HISTORIC AND DESIGN REVIEW COMMISSION

December 20, 2017

HDRC CASE NO: 2017-630
ADDRESS: 429 DEVINE ST
LEGAL DESCRIPTION: NCB 2957 BLK 1 LOT 8
ZONING: R-5, HS
CITY COUNCIL DIST.: 1
DISTRICT: Lavaca Historic District
LANDMARK: House
APPLICANT: Richard & Susan Theis
OWNER: Richard & Susan Theis
TYPE OF WORK: Construction of a single family residential structure
APPLICATION RECEIVED: December 01, 2017
60-DAY REVIEW: January 30, 2018
REQUEST:

DRAWING TITLE
SITE PLAN WITH
ZONING
SHEET 6

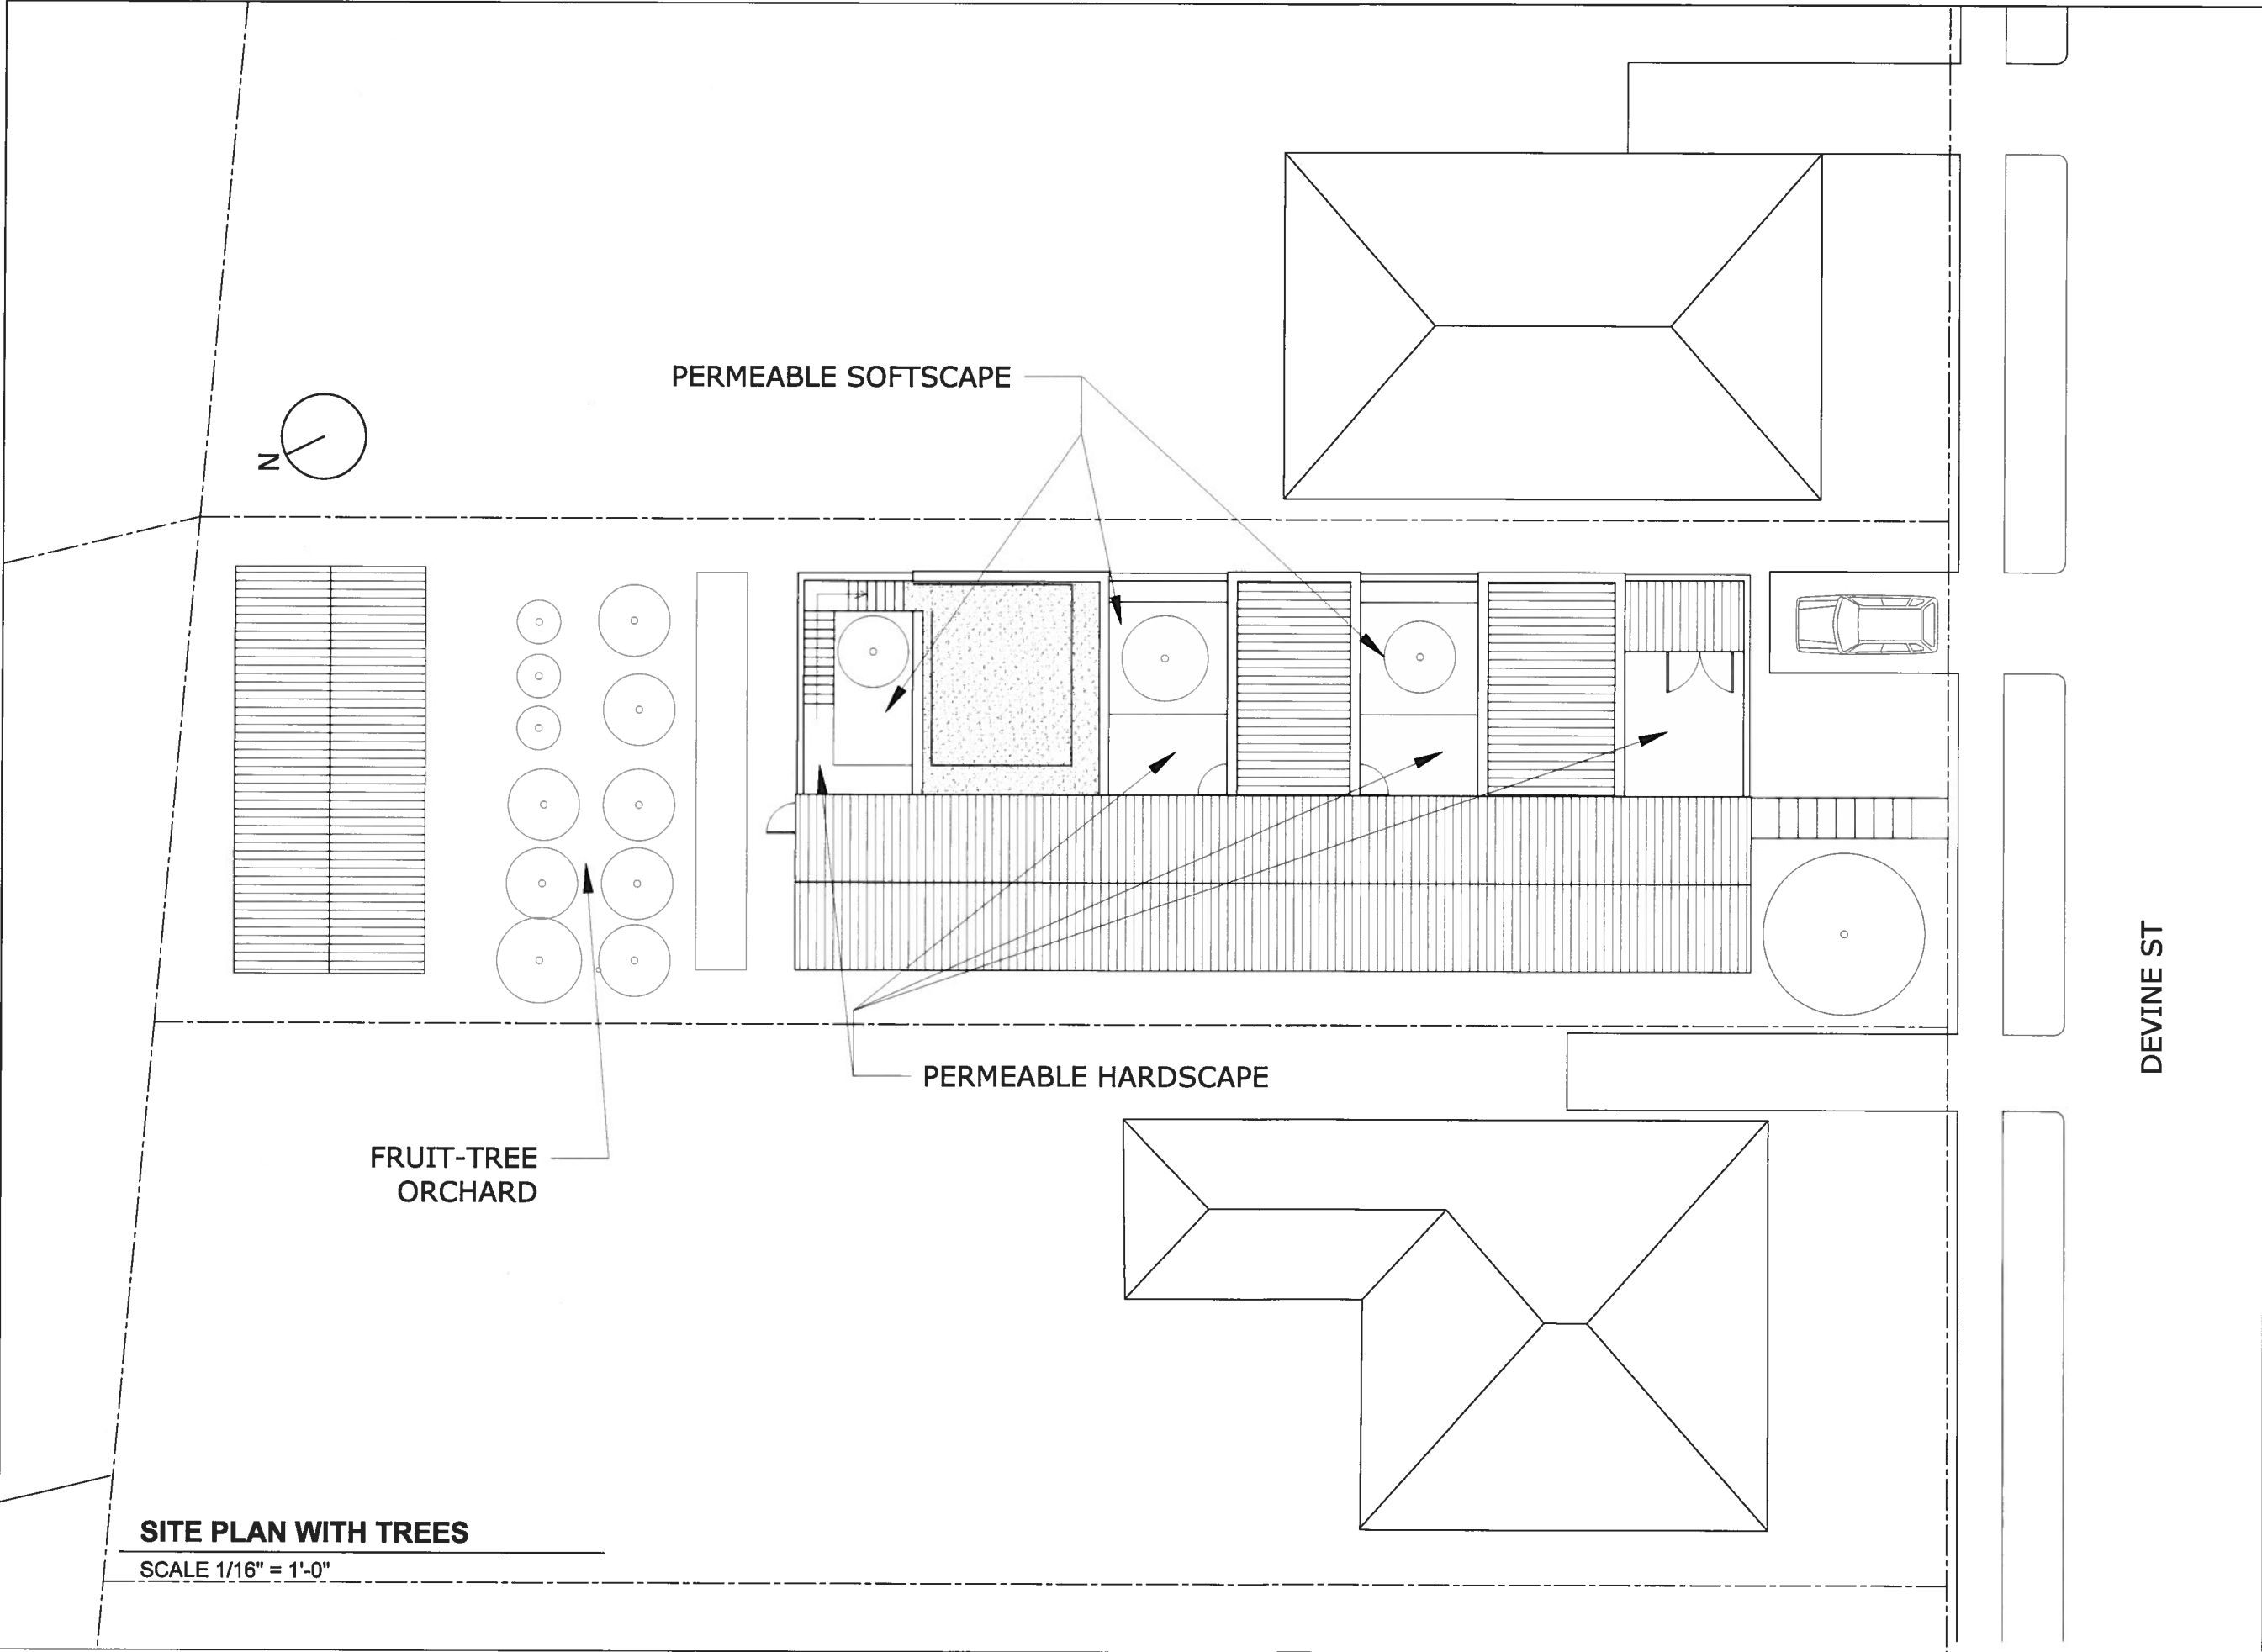
- b. SETBACKS & ORIENTATION – According to the Guidelines for New Construction, the front facades of new buildings are to align with front facades of adjacent buildings where a consistent setback has been established along the street frontage. Additionally, the orientation of new construction should be consistent with the historic examples found on the block. The applicant has noted per application documents that the proposed new construction will align with the front porch of the house to the west and the front façade of the house to the east. Staff finds that the proposed new construction should feature an overall setback that is greater than those of the primary historic structures.

- n. **DRIVEWAY** – The applicant has proposed a single vehicle parking location utilizing the existing curb cut and a proposed shallow driveway. Per the Guidelines for Site Elements 7.A.ii., off street parking areas should not be added within the front yard setback as to not disrupt the continuity of the streetscape. Staff finds the installation of a driveway to be appropriate; however, the driveway should follow the historic example found on the block and extend along the side of the proposed new construction rather than stop at the front of the proposed new construction.

- q. **SIDEWALK** – The applicant has proposed a front yard sidewalk to lead from the sidewalk at the public right of way to the front door. The proposed sidewalk should align with the front door and should feature a width consistent with those found historically in the district; typically three to four feet in width.

- i. That the proposed new construction features an overall setback that is greater than those of the primary historic structures as noted in finding b.

- ix. That the proposed driveway be modified as to not present front yard parking as noted in finding n.
- x. That all mechanical equipment is screened from view at the public right of way as noted in finding m.

- xi. That the proposed accessory structure features material detailing consistent with that of the primary structure as noted in finding o.
- xii. That the proposed sidewalk align with the front door and should feature a width consistent with those found historically in the district; typically three to four feet in width as noted in finding q.

DRAWING TITLE
ELEVATIONS

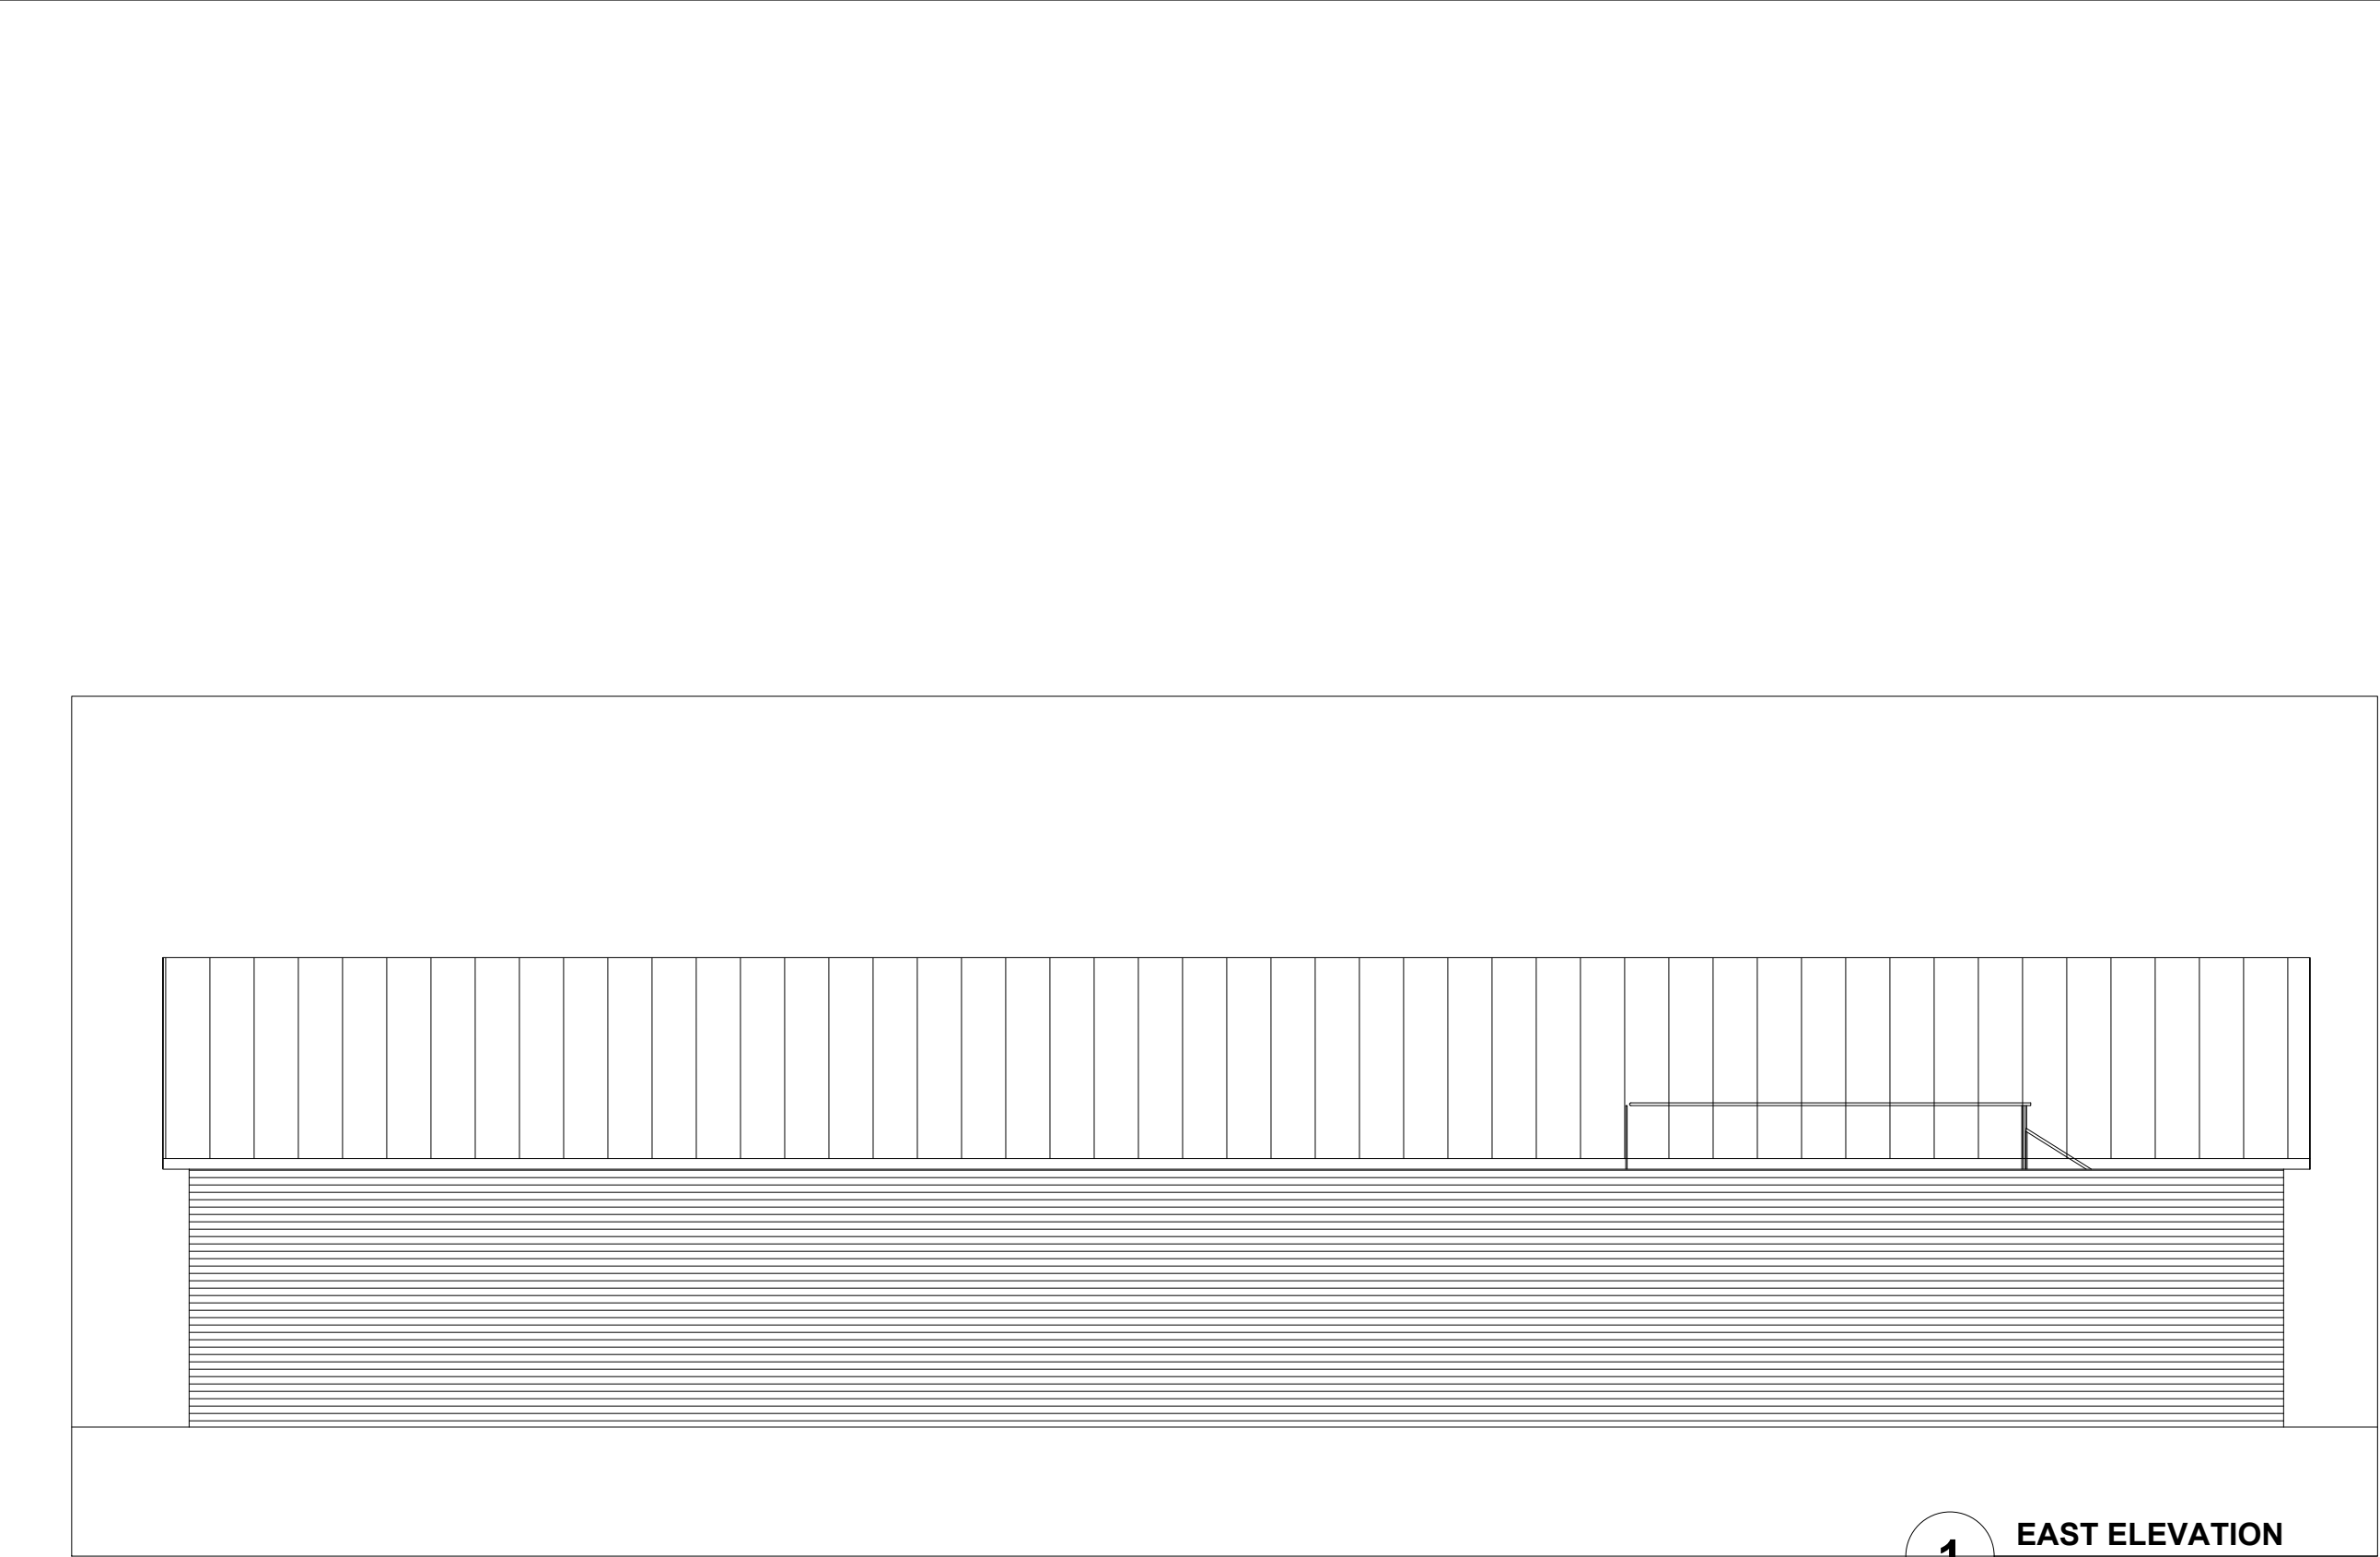
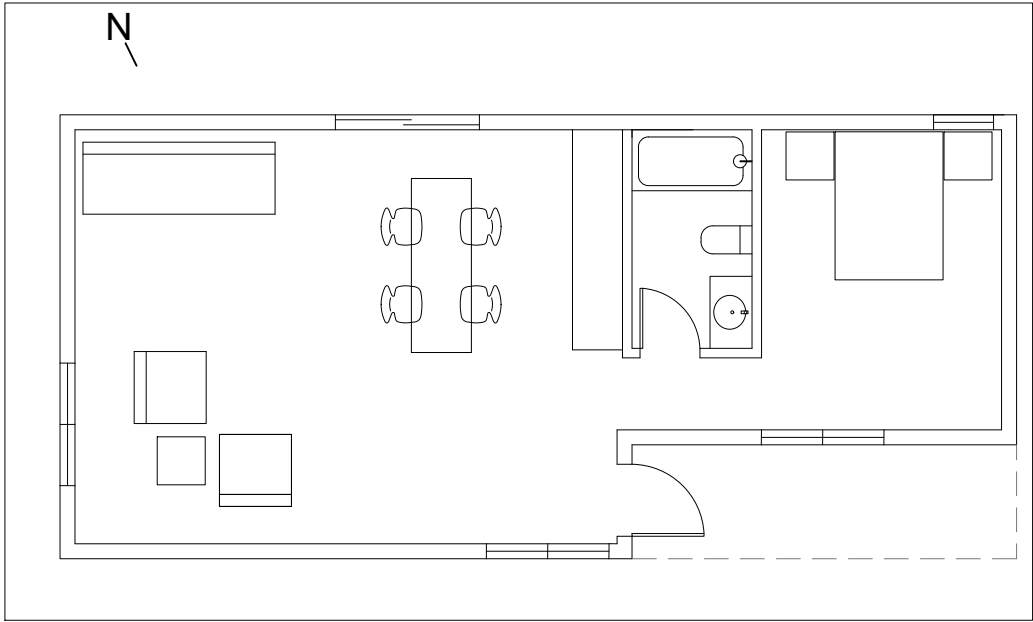
- d. PORCH MASSING – Historic structures throughout the Lavaca Historic District feature front façade massing with recessed front porches. The applicant has proposed a front façade which is flat and features no porch element. Staff does not find this to be appropriate. Staff recommends the applicant introduce porch massing that is complementary of the historic porches found along this block and throughout the district.

- g. ROOF FORM – The applicant has proposed roof forms to include a street facing gabled roof and a flat roof. The street facing gabled roof is a form found historically throughout the Lavaca Historic District; however, flat roofs are not found historically throughout the district.

- h. WINDOW & DOOR OPENINGS – Per the Guidelines for New Construction 2.C.i., window and door openings with similar proportions of wall to window space as typical with nearby historic facades should be incorporated into new construction. The applicant has proposed window and door openings that feature sizes that are contemporary in nature. Staff finds that window and door openings that closer relate to those found historically throughout the district should be installed. Fixed windows are not appropriate. All windows should feature an operable sash. The overall fenestration pattern should also follow the established ratio of solids to voids. As proposed, the large areas of blank wall space are a significant departure from this Guideline.

be appropriate; however, the staff finds that the applicant should address the current lack of porch massing, current lack of window openings that relate to those found on historic structures throughout the district and address the currently proposed flat roof on the street facing façade.

- vii. That the overall fenestration pattern be substantially revised to eliminate blank walls, in particular on the front façade. The fenestration pattern must follow the established ratio of solids to voids as demonstrated on nearby historic homes.

- viii. That the proposed flat roof portion of the primary façade be modified to become more consistent with historic, street facing facades found on the block as noted in findings g and l

- ii. That the introduce a porch configuration that is compatible with the historic porches found along this block and throughout the district as noted in finding d.

- v. That window specifications as noted in finding k are met. A detailed wall section should be submitted to staff for review.
- vi. That window openings that are complementary of those found historically in the district in regarding of size, head and sill height are installed as noted in findings h and l.
